**Responses to RAI-1, on the ES-3100 Type-B Shipping Container
Docket No. 71-9315, TAC No. L23818**

**Response to RAI # 1
Docket No. 71-9315
TAC No. L23818**

**SAFETY ANALYSIS REPORT,
Y-12 NATIONAL SECURITY COMPLEX,
MODEL ES-3100 PACKAGE WITH BULK HEU CONTENTS**

Fig. 1. Strain in the Kaolite - HABCrn4g.

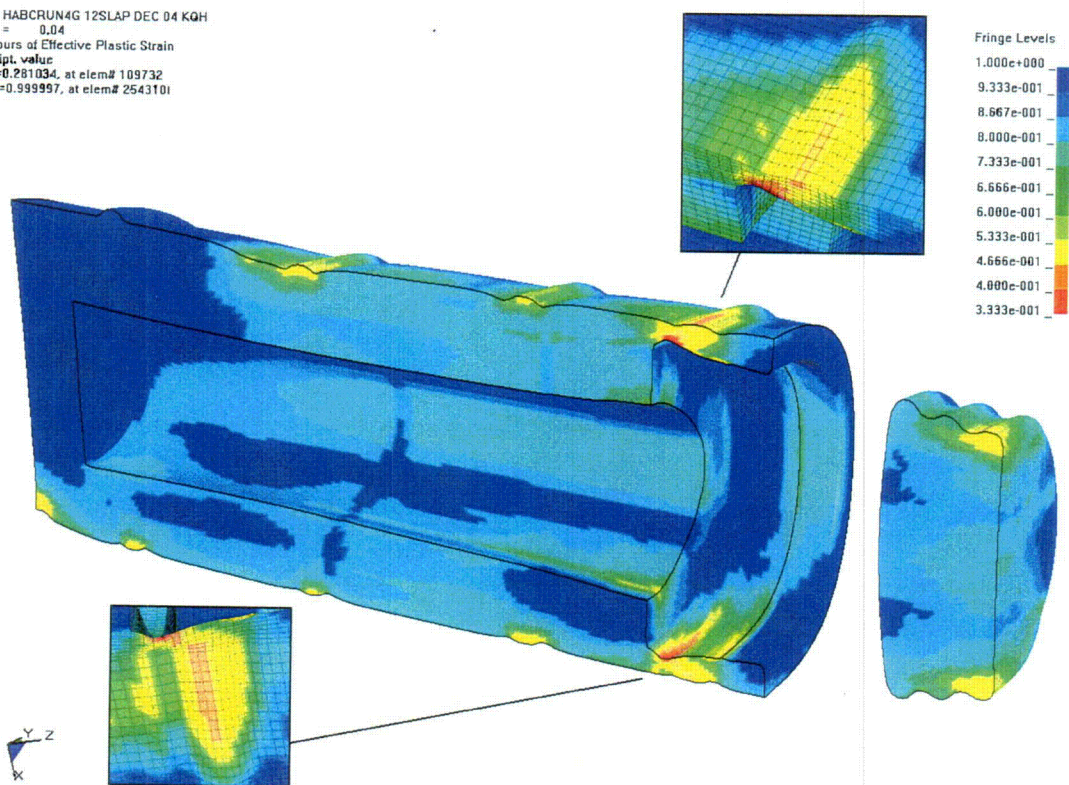
2-13 Provide methodology and justification for the extrapolation beyond 0.6 volumetric strain for the Kaolite 1600 material.

The methodology used for the extrapolation of the Kaolite data above the test range is similar in nature to that explained in the response to RAI 2-12. LS-DYNA will not extrapolate material data curves. If the end of the material data curve is reached in a solution, the solution will be stopped due to an instability. Therefore, a "lock-up" point (point at which all voids have collapsed) or an extreme point needs to be defined before the solution is started. This point and the transition from the test data to this point are assumed data points (not supported by test data). In general, the Kaolite state of strain throughout the 10 CRF 71 required impacts is within the test data region (i.e., the "lock-up" point is not reached). The regions of Kaolite which exceed the test data in the solution are typically very localized and occur at corners or localized regions. The HABCrn4g response is chosen to demonstrate this point due to the fact that it is a slapdown impact with secondary impact on the drum lid end and the crush occurs at the lid end, thereby tending to elevate the compressive demand on the Kaolite at the lid end. Figure 1 shows the strain for the Kaolite drum material and the plug. The data range has been adjusted such that strains in excess of the test data range are shown in red ($1 - 0.6 = 0.4$). It can be seen that most of the Kaolite experiences volumetric strains less than 0.6 in./in. (or, greater than 0.4 in Fig. 1), which is the test data range.

Fig. 1. Cross-sectional view of the lid assembly at a stud.

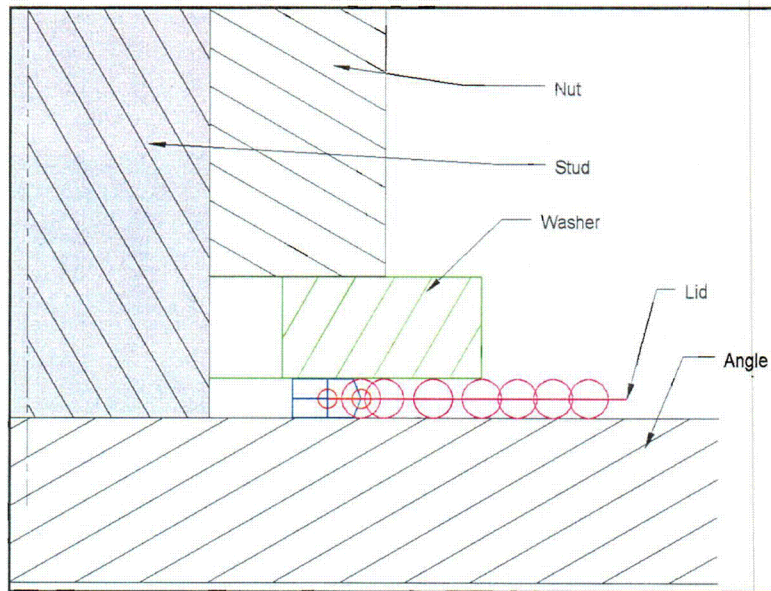
Figure 2.1.7 on page 2-173 of the SAR shows a shell to solid element transition for the drum lid. The load path in this region is from the nut to washer in bearing and from the washer to lid in bearing. Eliminating the bearing surfaces prematurely may have an impact on the stress distribution in this region.

Figure 1 shows an enlarged cross-sectional view of the stud/angle/lid model used on the ES-3100. The centerline of the stud is to the left in the figure. The nut, stud, washer and angle are all modeled with solid elements and their outlines are shown in Fig. 1. The blue colored elements depict the solid elements used in the 3100 lid model and the lid shell elements are modeled at the centerline and are shown by the magenta colored straight line. The purpose of the solid elements at the studs in the lid model is to provide a solid element contact surface with the stud during shear.

Fig. 1. SAR HABC-run2e, deformed configuration.

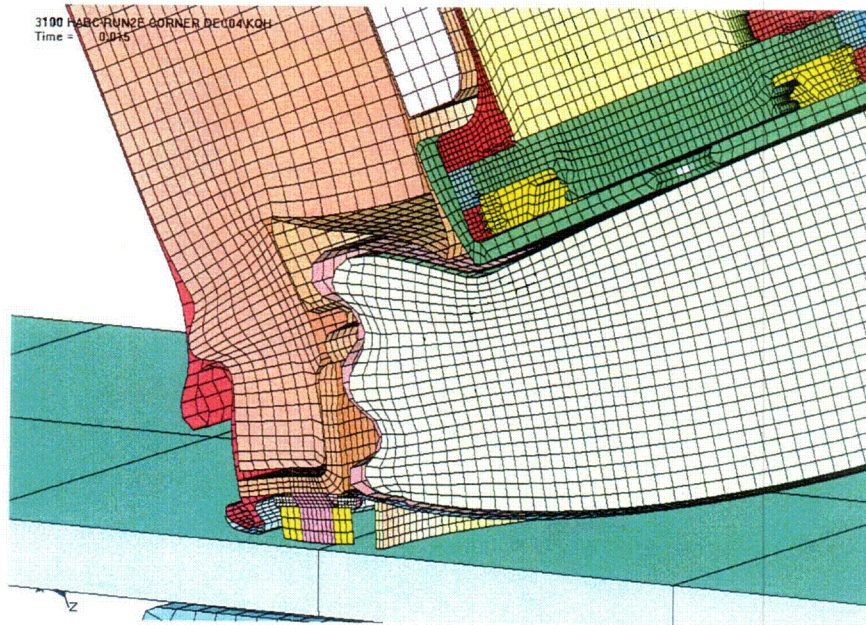
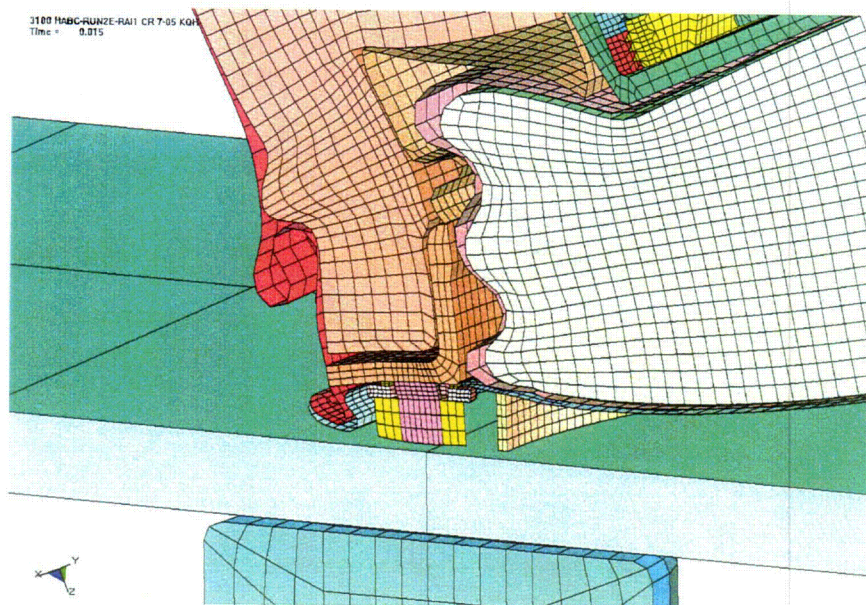
The configurations at the end of the 30-ft impact (time = 0.015 s) in the vicinity of the impacting stud are shown in Figs. 1 (SAR) and 2 (RAI). Figure 1 is the same as the insert in the SAR Fig. 7.3.1 on page 2-402. Comparison of the figures shows that the shear deformation in the stud is more dramatic in the SAR model. This is to be expected with the relatively softer engineering stress/strain model compared to the true stress/strain values in the power law model.

Fig. 3. SAR HABC-run2e, plastic strain in the studs.

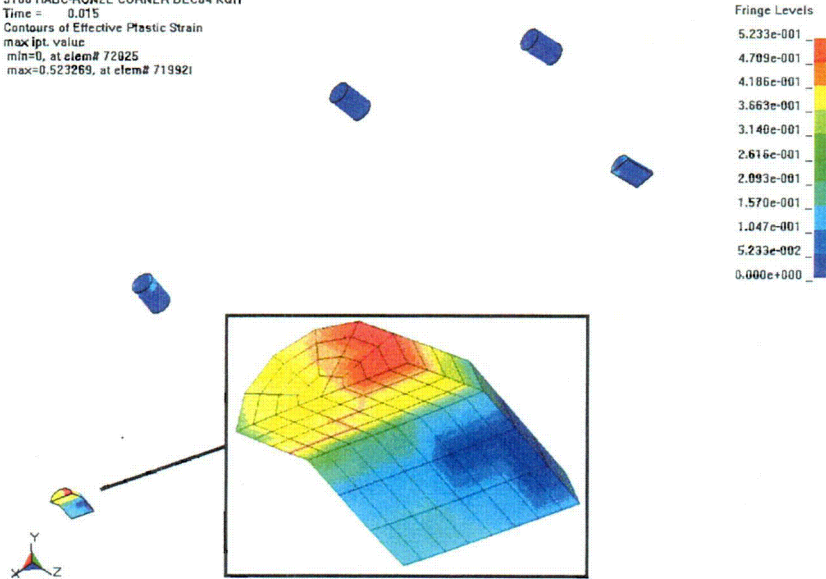
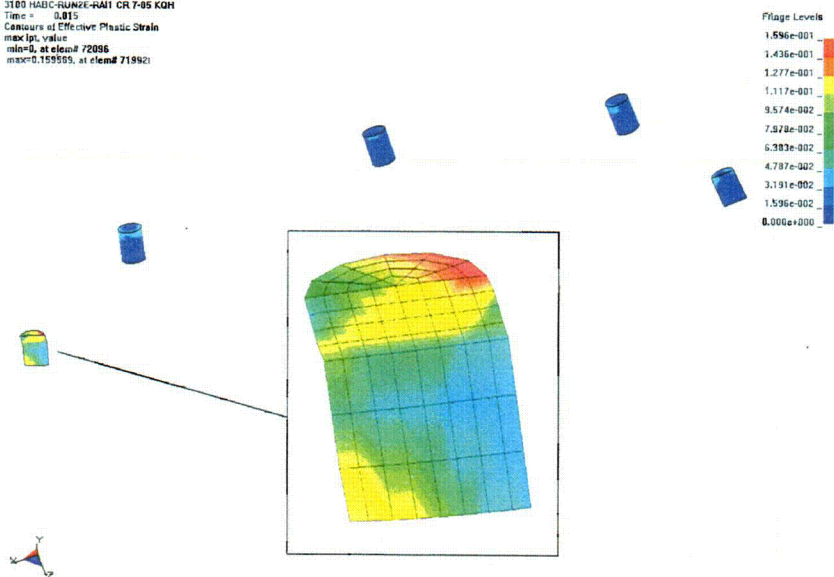
The effective plastic strain in the studs is shown in Figs. 3 (SAR) and 4 (RAI). An enlarged view of the stud at the initial impact corner is included in each figure. Figure 3 is the same as the SAR Fig. 7.3.4 on page 2-403. The SAR model maximum strain is 0.523 in./in. and the maximum strain in the RAI model is 0.160 in./in. This result is to be expected due to the differences between the two material models.

Fig. 5. SAR HABC-run2e, plastic strain in the lid.

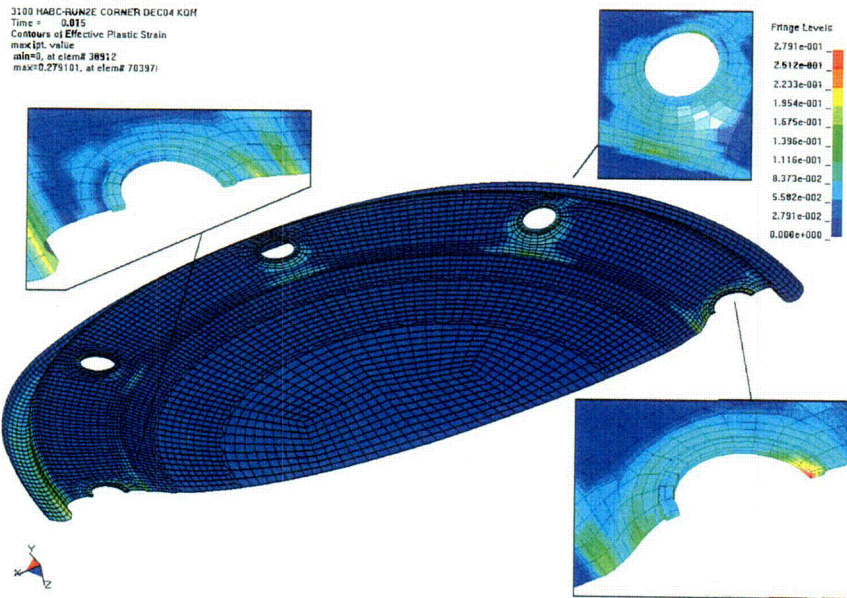
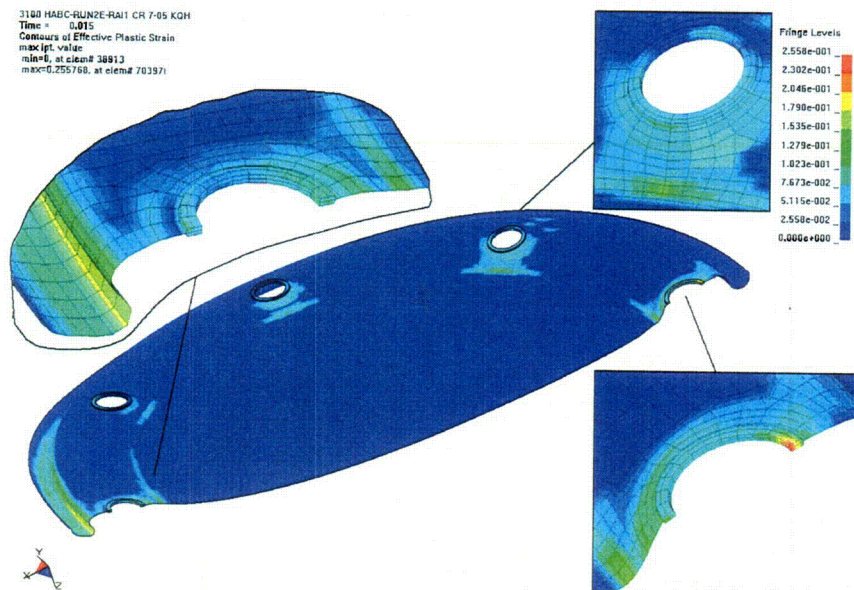
The effective plastic strain in the lid is shown in Figs. 5 (SAR) and 6 (RAI). Figure 5 was not included in the SAR, but its maximum was recorded in the SAR Table 8.0.1, page 2-457 (0.2791 in./in.). The maximum strain in Fig. 6 (RAI) is 0.256 in./in. In each figure, the maximum is located near the stud on the plain of symmetry, opposite the initial impact.
